TENNESSEE VALLEY AUTHORITY

August 17, 1984

ENCLOSURE
SUPPLEMENTAL RESPONSE
NRC INSPECTION REPORT NOS.
50-259/84-12, 50-260/84-12, AND 50-296/84-12,
RICHARD C. LEWIS' LETTER TO H. G. PARRIS
DATED MAY 2, 1984

ATTACHMENT B

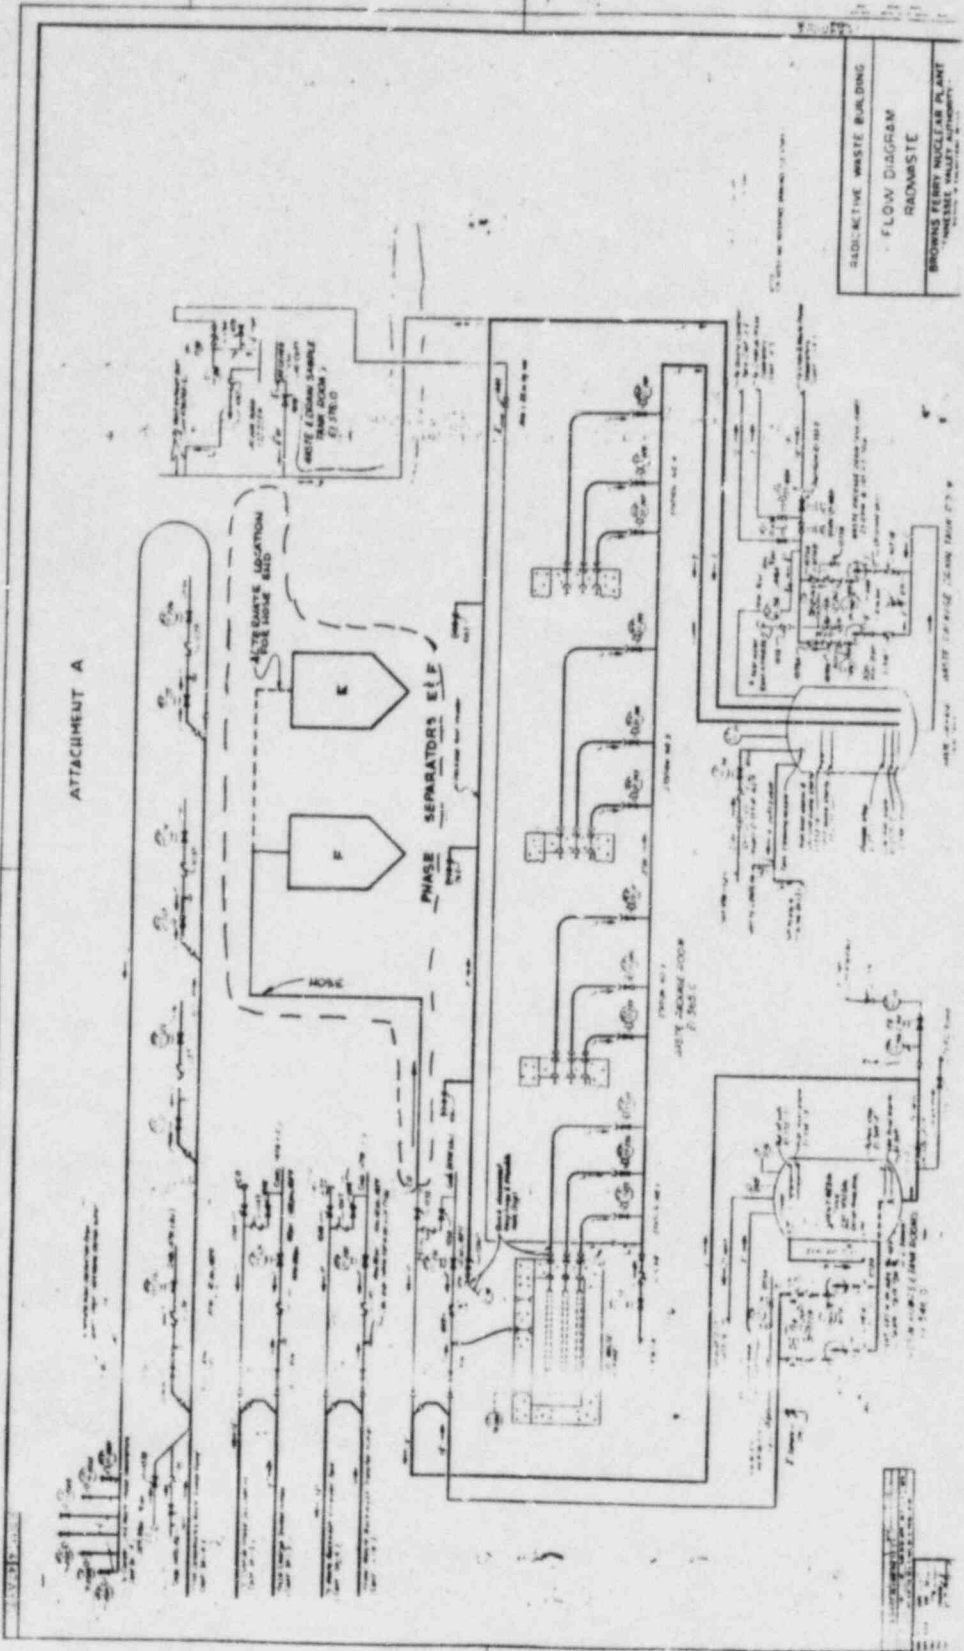
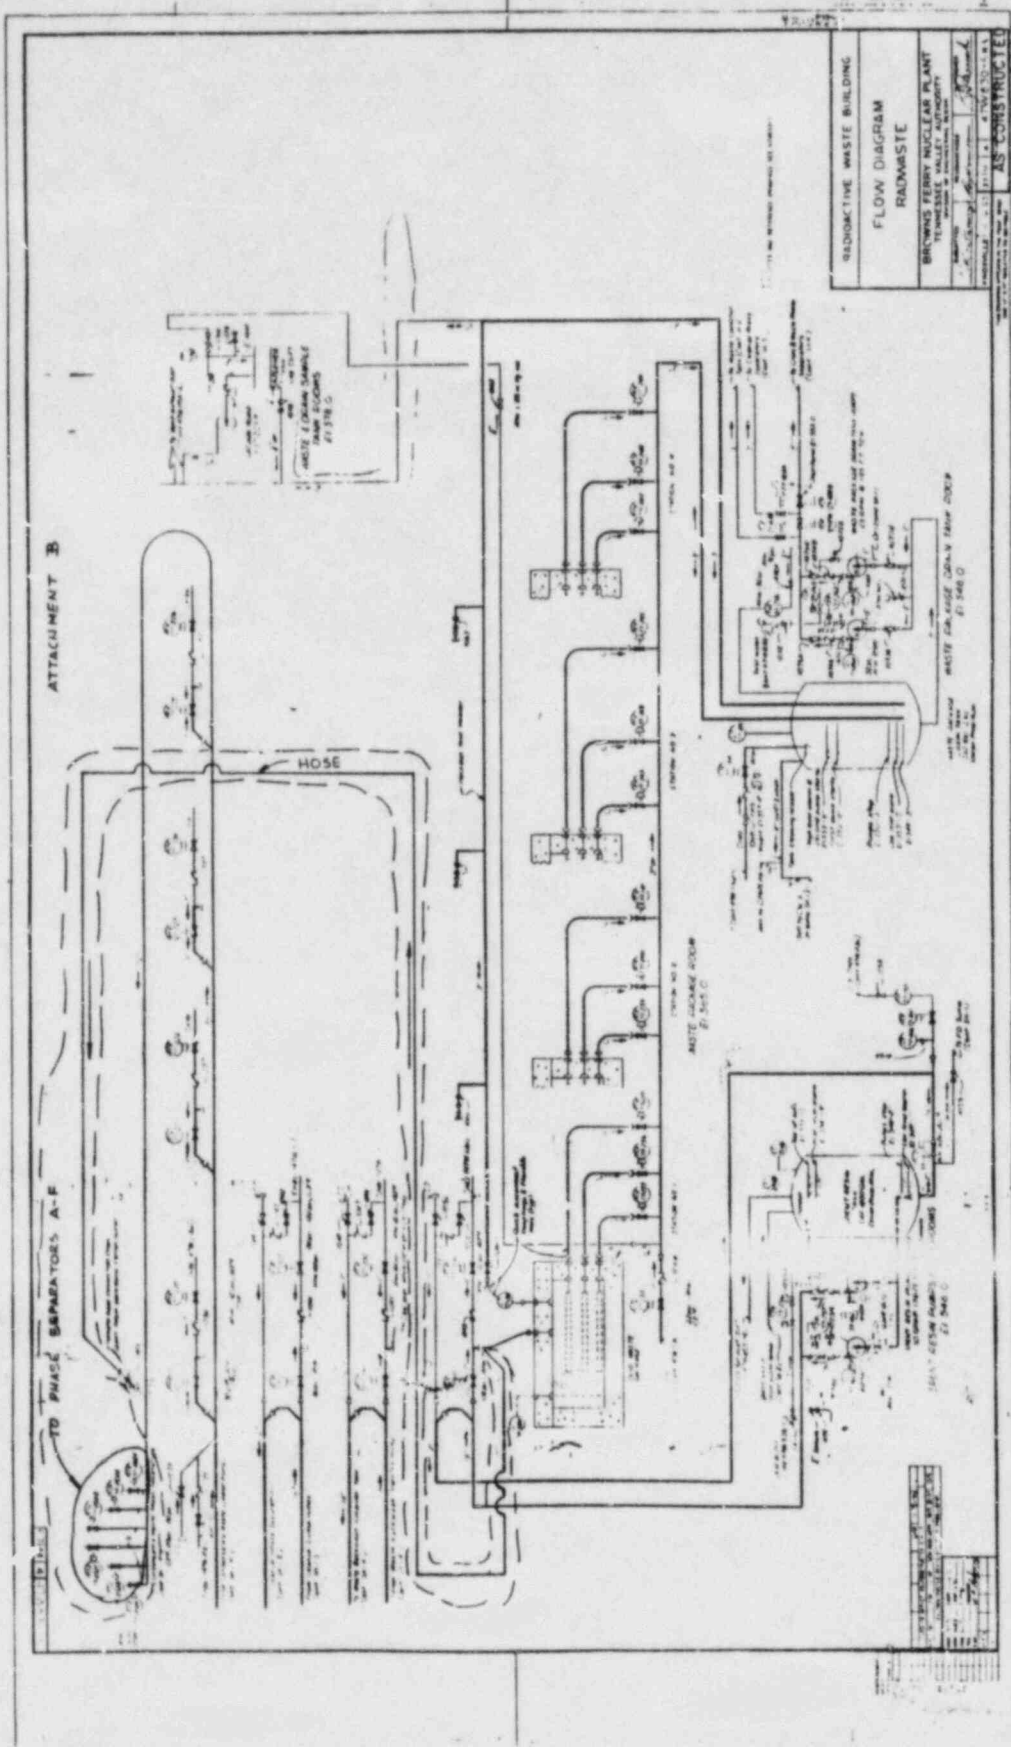
10 CFR 50.59 evaluation of the change to the radioactive waste system concerning mixing of bead and powder resins, which is not addressed in the FSAR.

Section 9.3 of the FSAR contains both a written description of the solid radwaste system and a flow drawing (figure 9.3-1A). This figure agrees with the text and shows both bead and powdered resin slurries being routed to the common waste packaging area. The figure contains small details such as hose connections, flush lines, and liner internals not mentioned in the text. Just because these details are not mentioned in the text does not lessen their importance, nor does it prohibit their use in meeting the systems design basis. It is Browns Ferry's use of these small details that require further clarification. Attachment A is a copy of figure 9.3-1A marked to show how plant personnel attached a reinforced rubber hose to transfer bead resin to waste phase separators 'E' or 'F.' It is clearly evident that the connection was made through a flush line and flow was in a direction opposite to that shown. This configuration is still in use and is preferred by plant personnel. Because the free end of the hose can only reside in one phase separator at a time, administrative control over bead resin mixing is maximized.

Attachment B is a copy of figure 9.3-1A marked to show the use of permanently installed hose connections to route bead resin from the spent resin packaging outlet to a common line leading to all six waste phase separators (A - F). The arrangement shown on attachment A was not evaluated to determine if an unreviewed safety question (10 CFR 50.59 evaluation) existed at the time of installation. Once plant personnel became aware of this oversight, a 10 CFR 50.59 evaluation was performed.

The key factor in performing the 10 CFR 50.59 evaluation was that the final result from using the configuration shown in attachment A is the same as from using the approved configuration shown on attachment B. Our evaluation was further confirmed in a memorandum from TVA Engineering Design that states: '. . . The design of the radwaste system did not preclude mixing of bead resin and powdered resin in a liner prior to disposal. An existing hose connection also allows upstream mixing in the phase separators. . . .'

The reasons for transferring bead resin to the phase separators and for mixing the resin types is explained in our original reply. These reasons result from operating experience gained after the FSAR was completed. The design of the solid radwaste system allows liners to be filled with either bead resin, powdered resin, or combinations of the two. The liners and dewatering equipment are common for all types of filter material handled by the solid radwaste packaging system. Plant personnel using the installed equipment have the responsibility of meeting all federal and burial ground criteria. Specific operating details and administrative controls necessary to meet these requirements are contained in plant procedures not in the FSAR. This allows the flexibility to change these instructions based on experience and to reflect changes in regulations. For instance, operating experience has demonstrated that the proper connection and sequencing of liner filter elements during the dewatering is important to meet the safety design basis. Operating experience has also demonstrated the need to exercise the option to transfer bead resin into the phase separators. The need for an unreviewed

safety question determination is dependent on the details of the proposed changes. In this particular case, we believe that mixing of the resin types is within the scope of the FSAR description, and that an unreviewed safety question determination was not required.
